BOARD OF ARCHITECTURAL REVIEW PUBLIC HEARING

CITY HALL, MARKET SQUARE GARAGE AND PLAZA RENOVATION

05 NOVEMBER, 2025

BUILDING ENTRY – CENTER BAY MATERIAL EXPLORATION

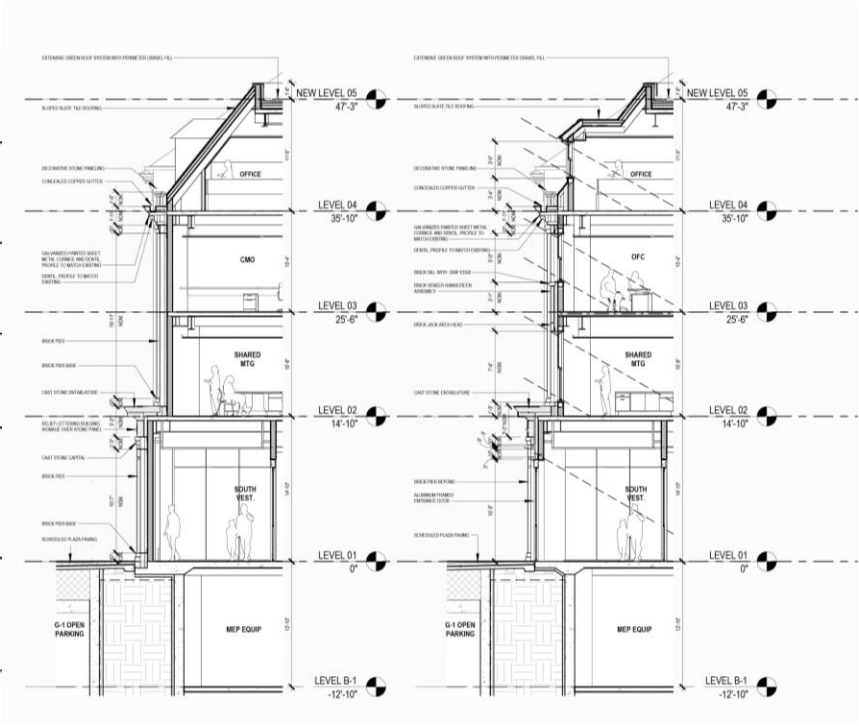
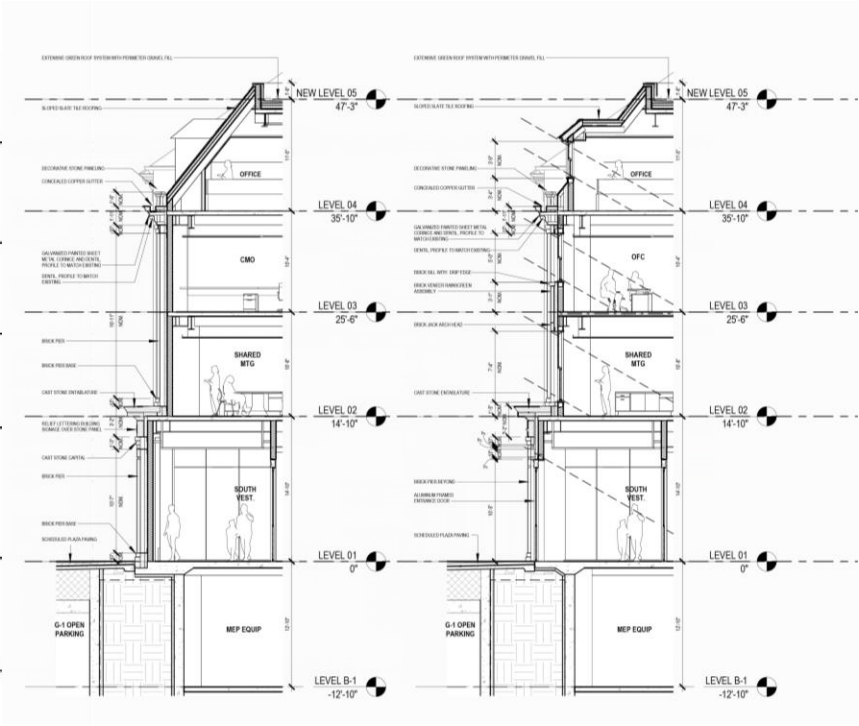
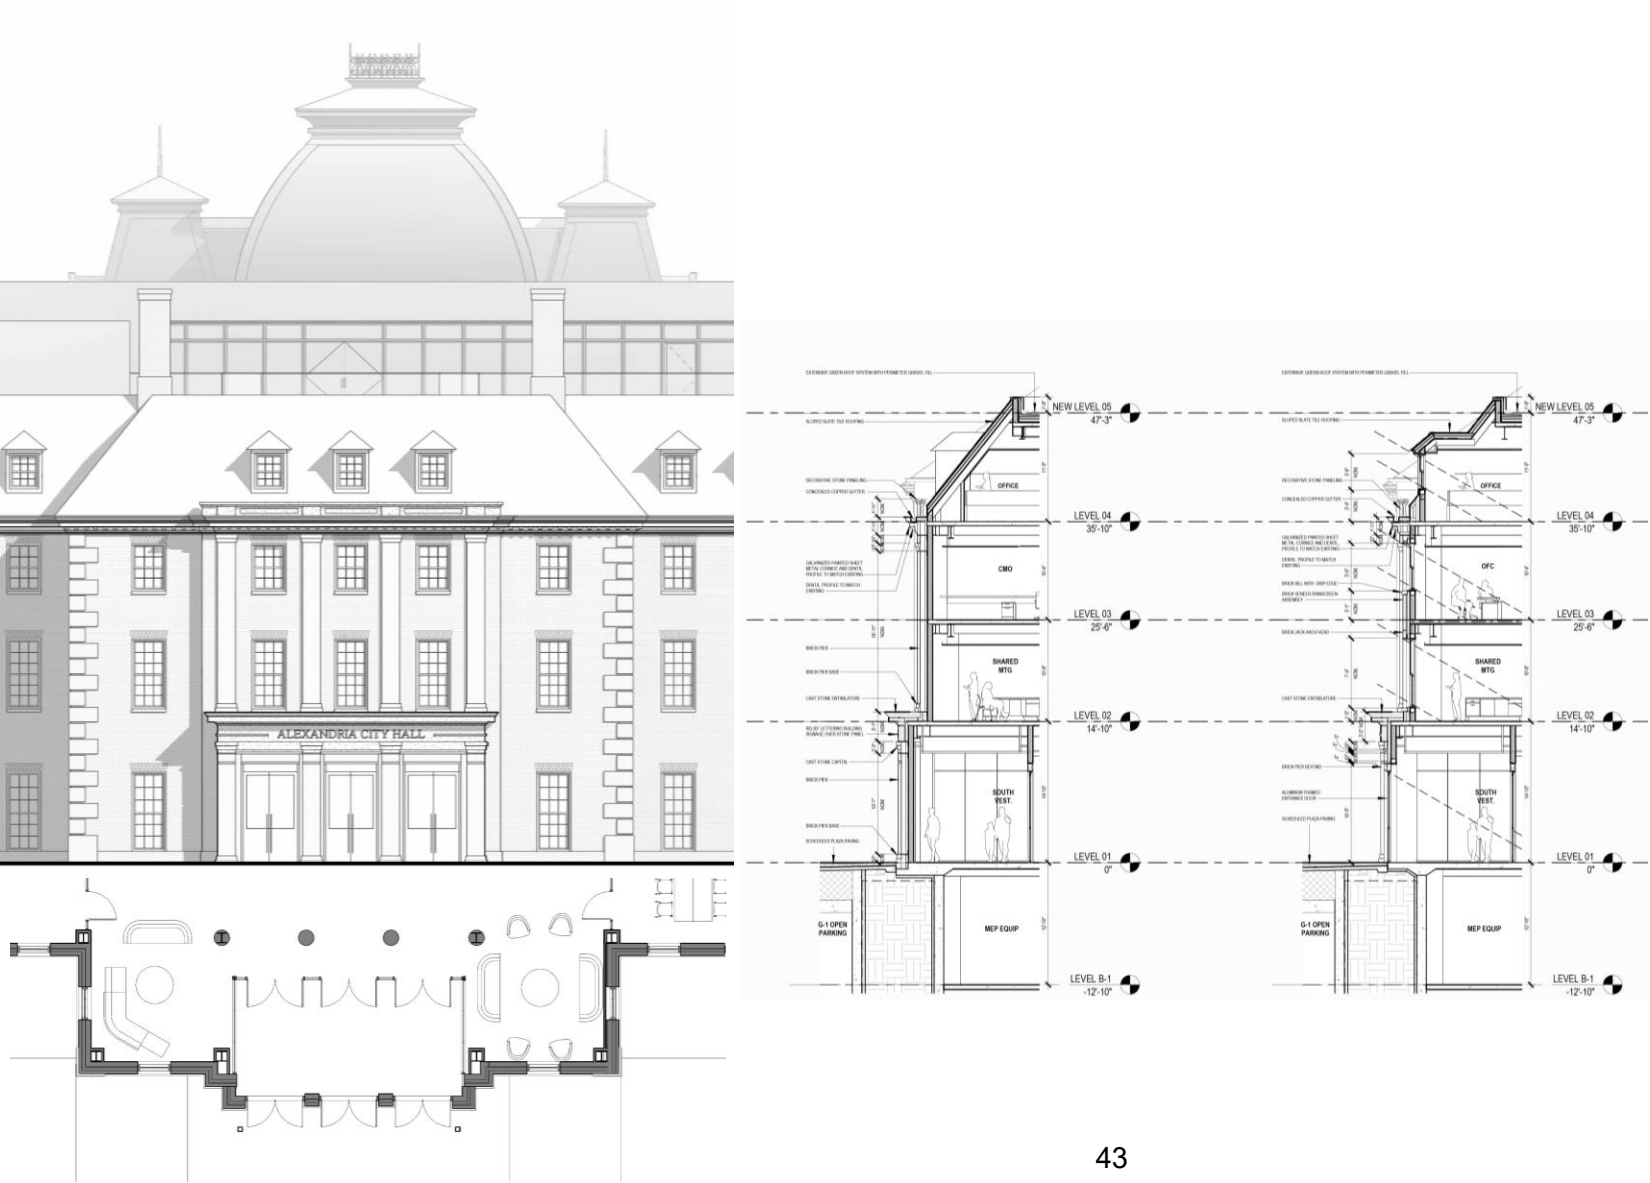
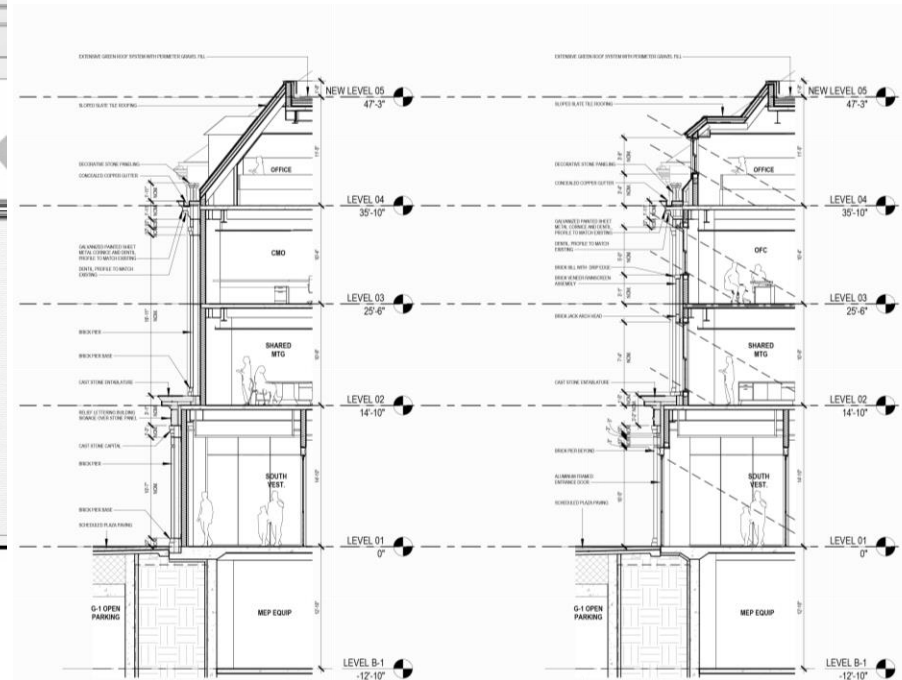
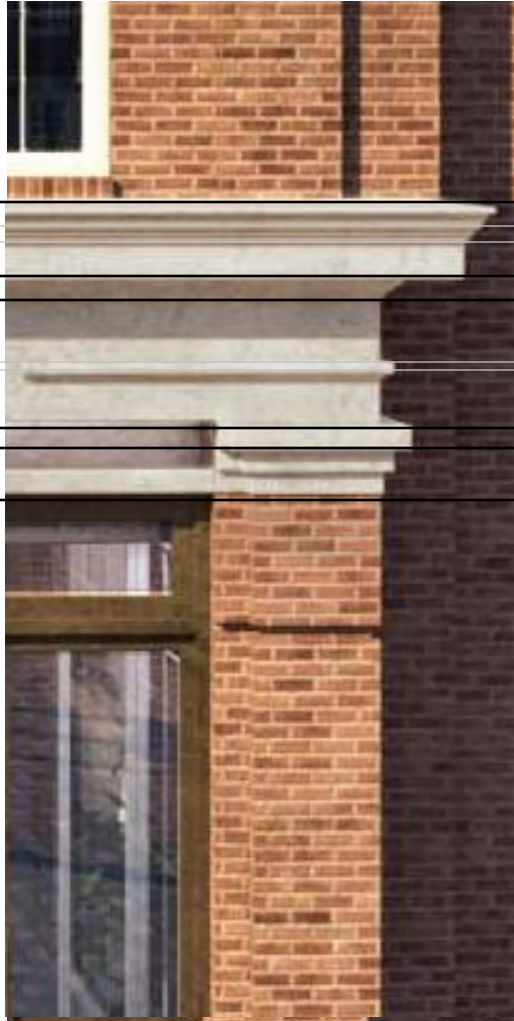
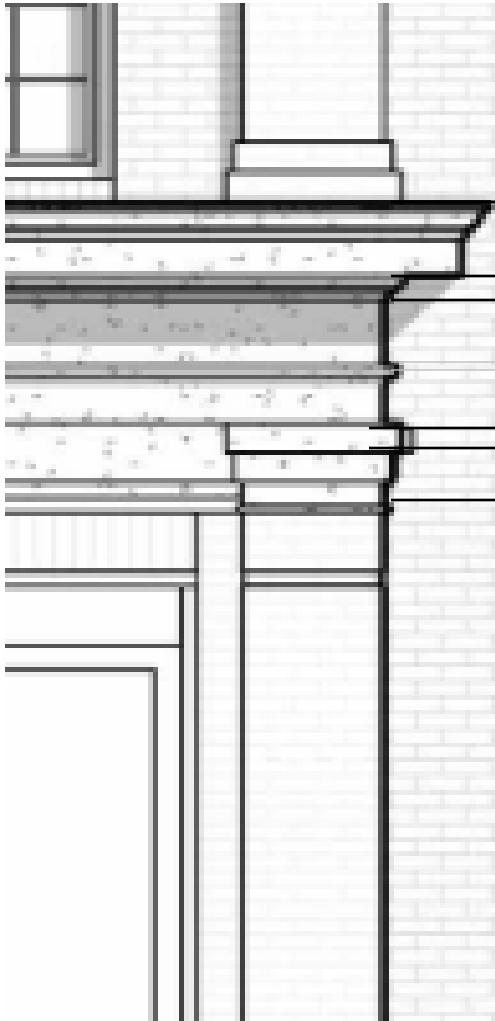
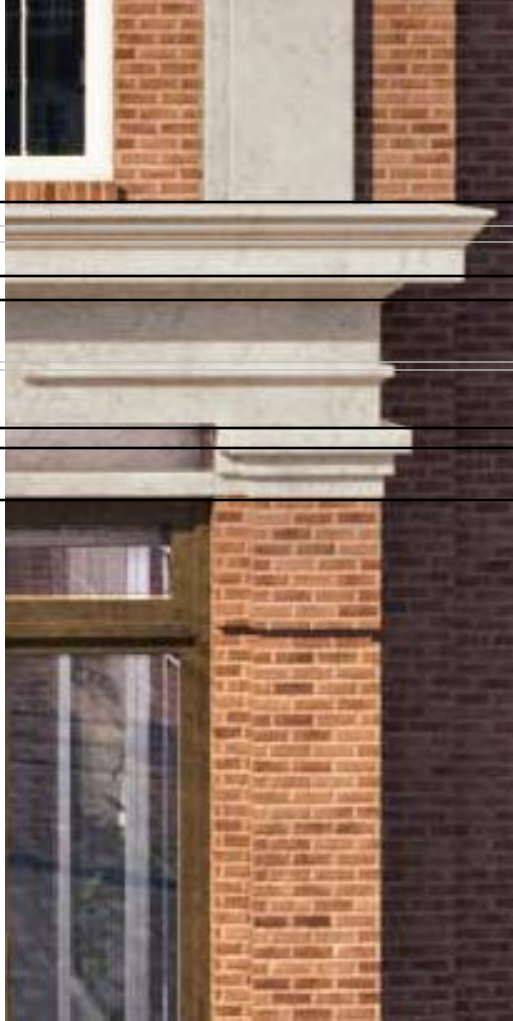
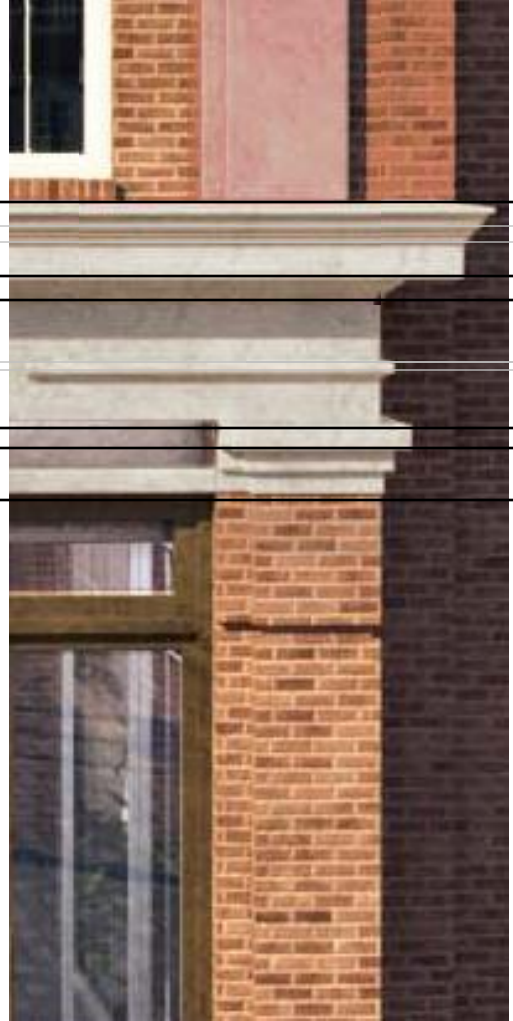
- I. 3-story expression comprised of pilasters & entablature with alternate materials – Studies for three options have been submitted for consideration - FOR SELECTION
- II. Roofline above central portion should remain as existing - ACCEPTED
- III. Chimneys – all options feature alternates with and without - FOR SELECTION
- IV. Brick infill transom or arched entryways at vestibule doors - FOR SELECTION

- OPTION A (BRICK-ON-BRICK) WITHOUT CHIMNEYS, WITH ORTHOGONAL BRICK INFILL ENTRIES AT VESTIBULE; AND,
- WORK WITH STAFF ON THE FOLLOWING:
 - MATCH RESTORATION MATERIALS TO HISTORIC COLOR/TEXTURE.
 - ALIGN FIFTH-FLOOR DESIGN WITH ADJACENT SLATE ROOFS.
 - DESIGN AND DETAILING AT SOUTH FAÇADE.
 - MARKET SQUARE PLAZA SHADE STRUCTURES.
